Addenda

Project: Wilshire Hills III

Addenda No.: 4

Project No.: 23034

AS-101

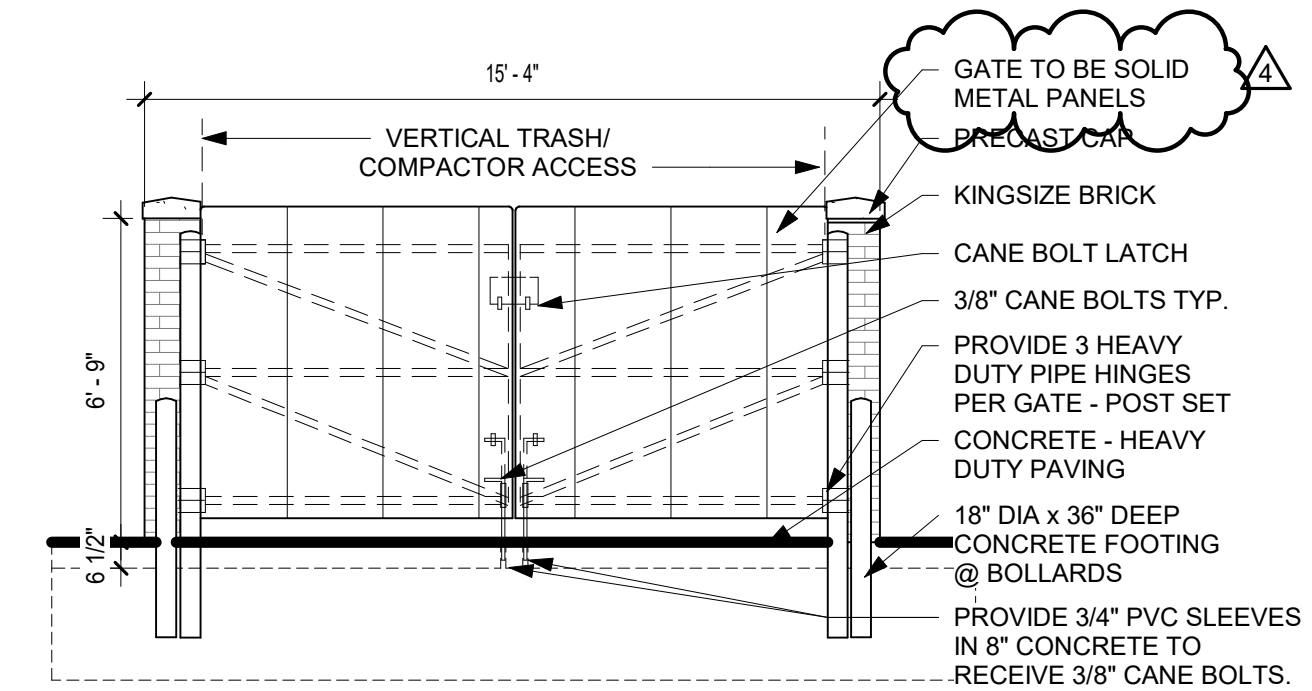
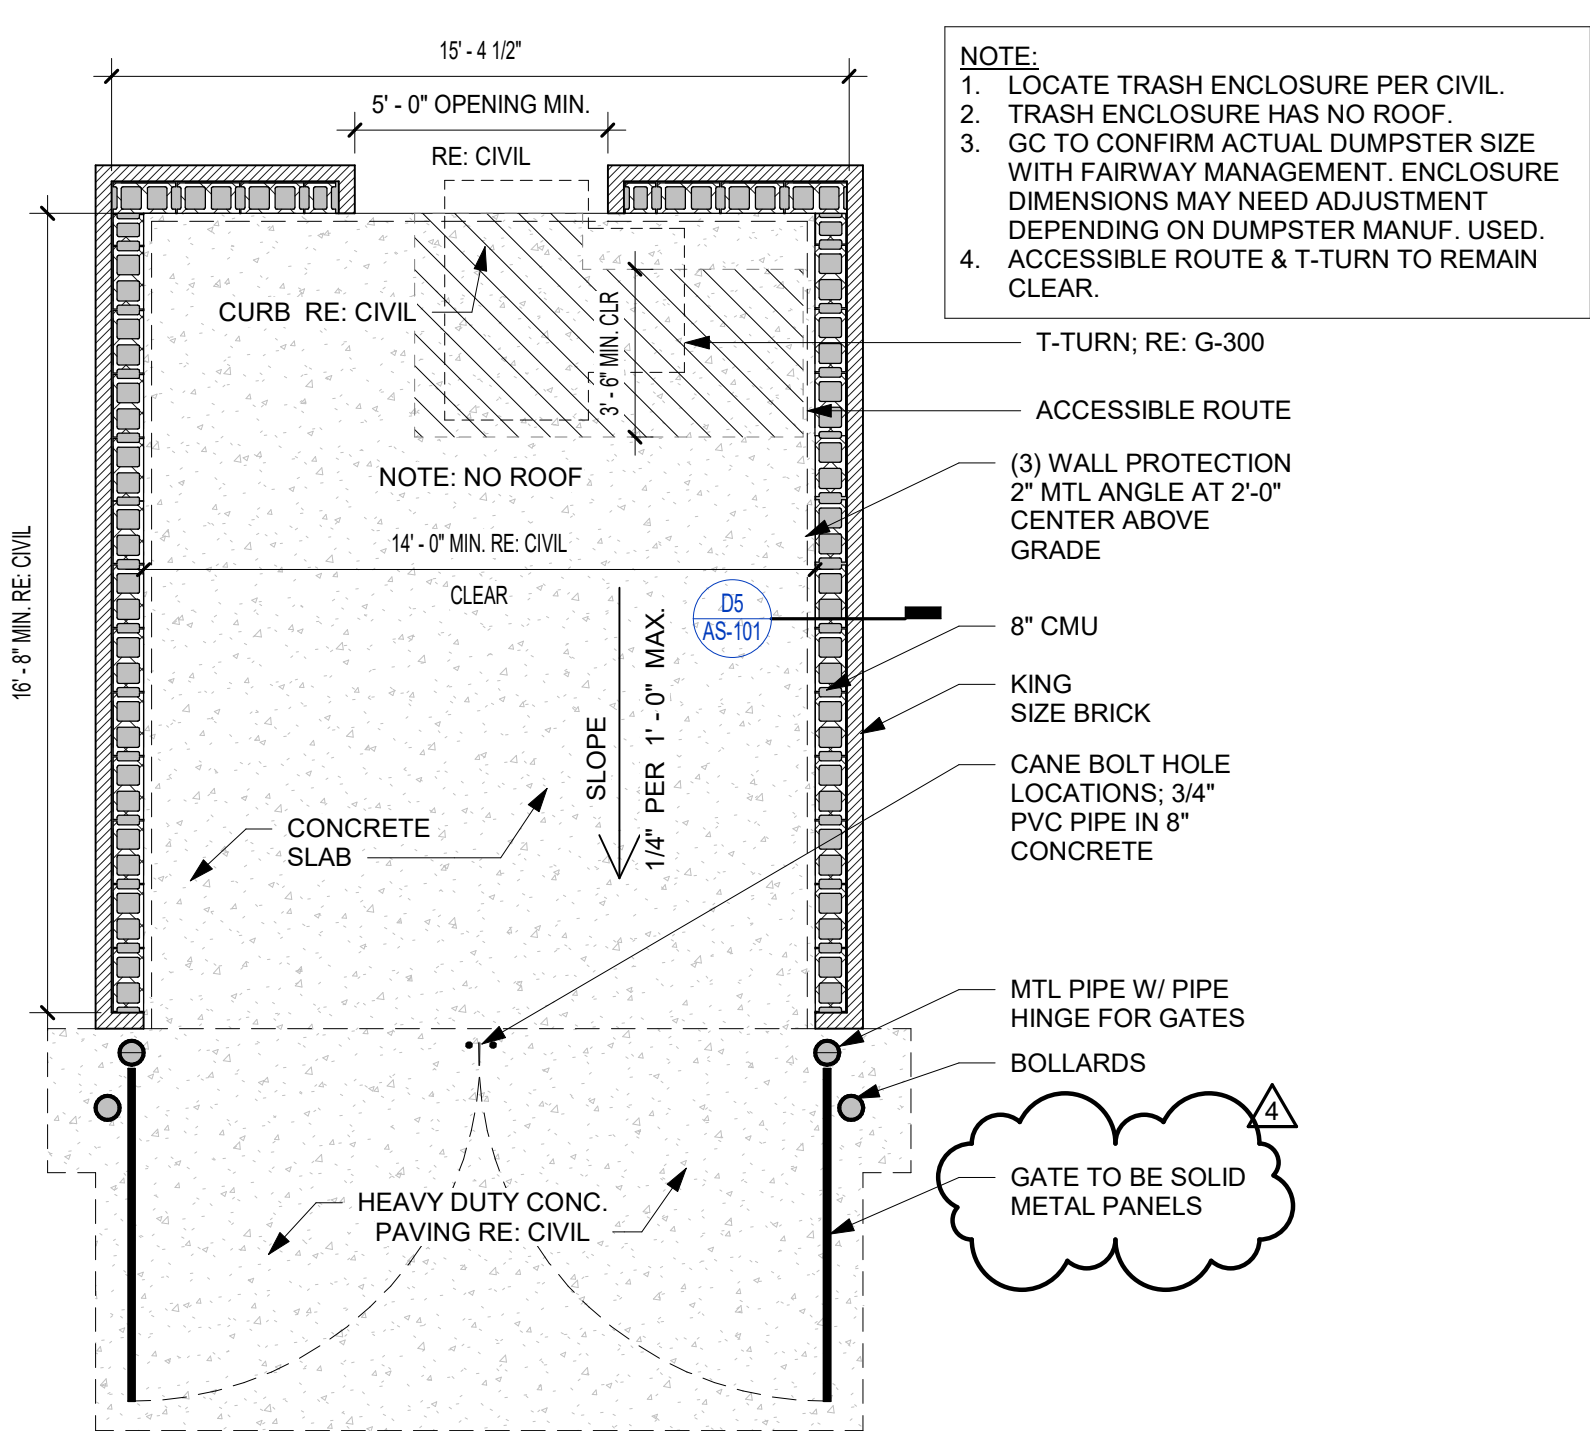
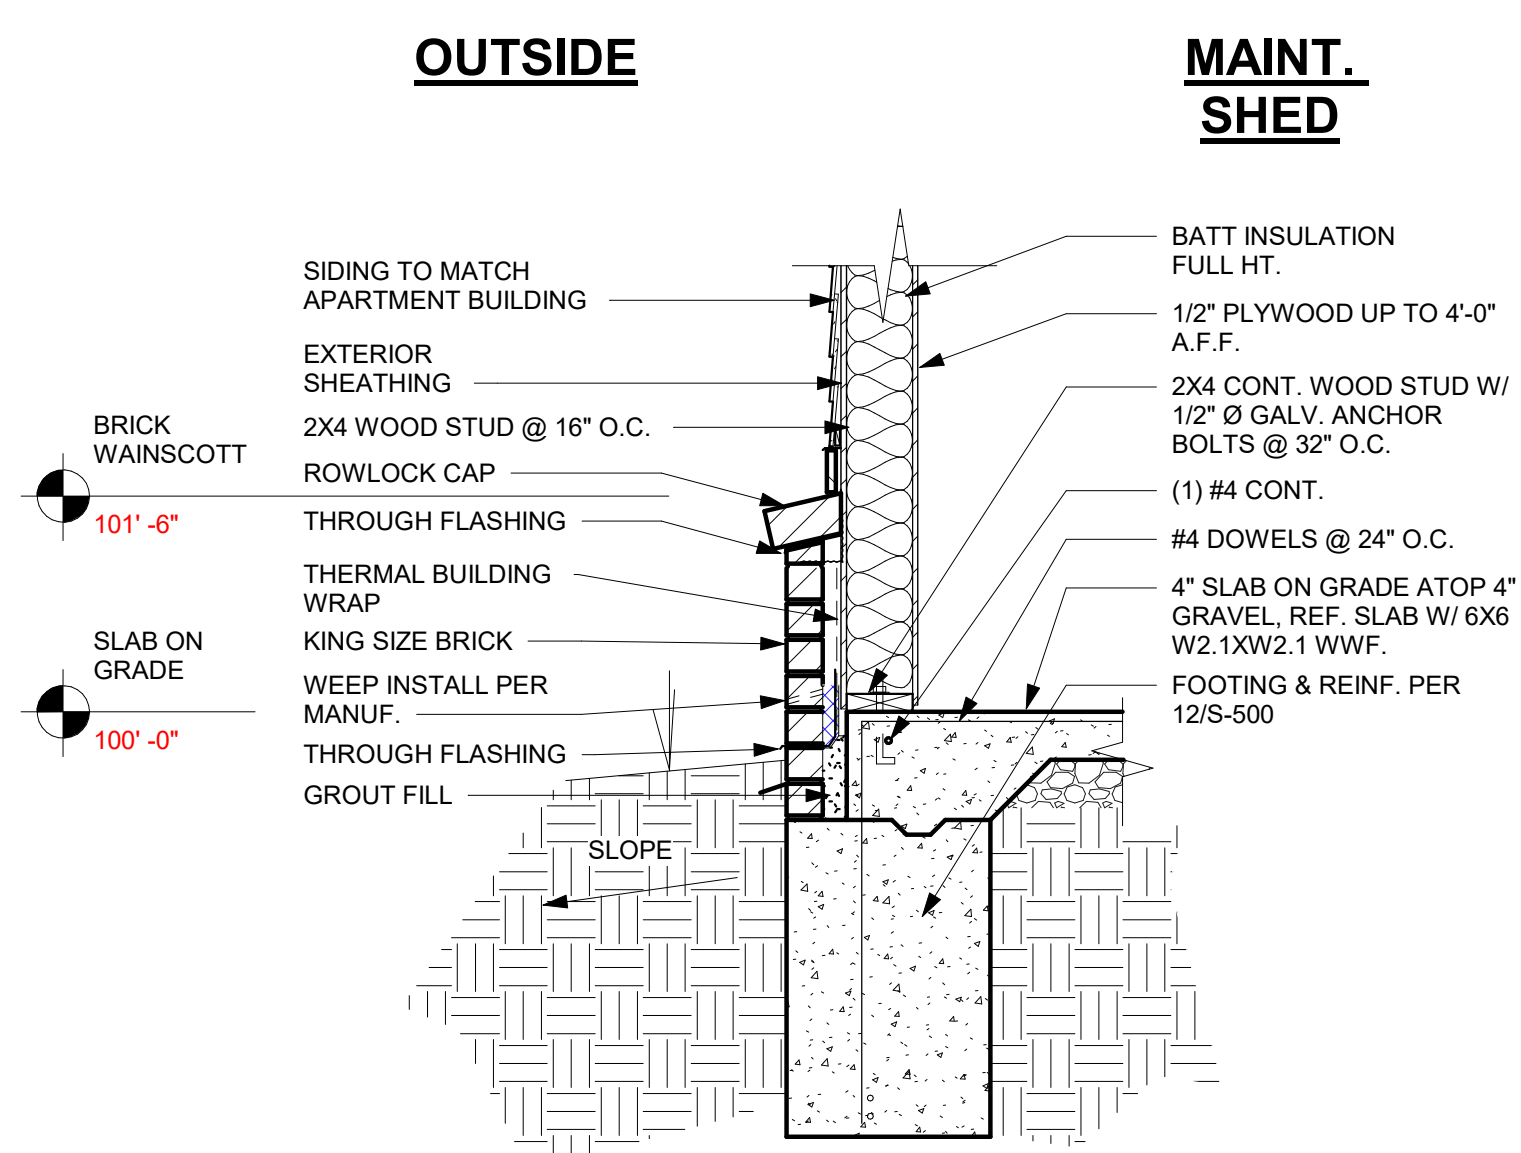
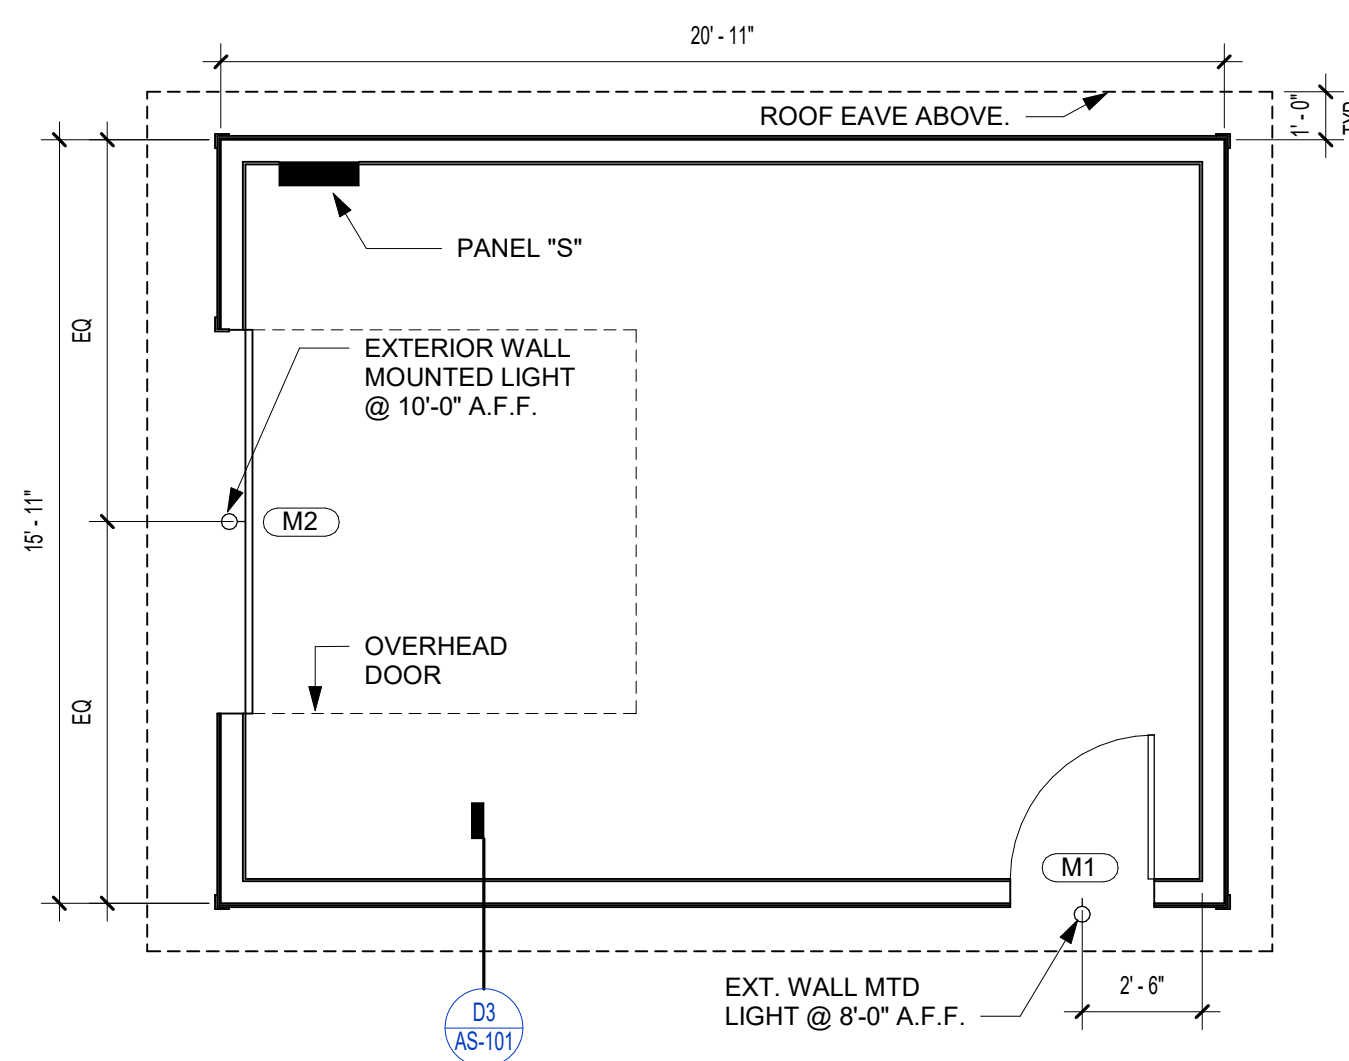
Construction Documents, ARCHITECTURAL SHEETS: Please replace sheet AS-101 dated 10/30/23 with sheet AS-101 dated 07/16/24. *Trash Enclosure Details updated. New AS-101 sheet has been attached to this Addendum #4.*
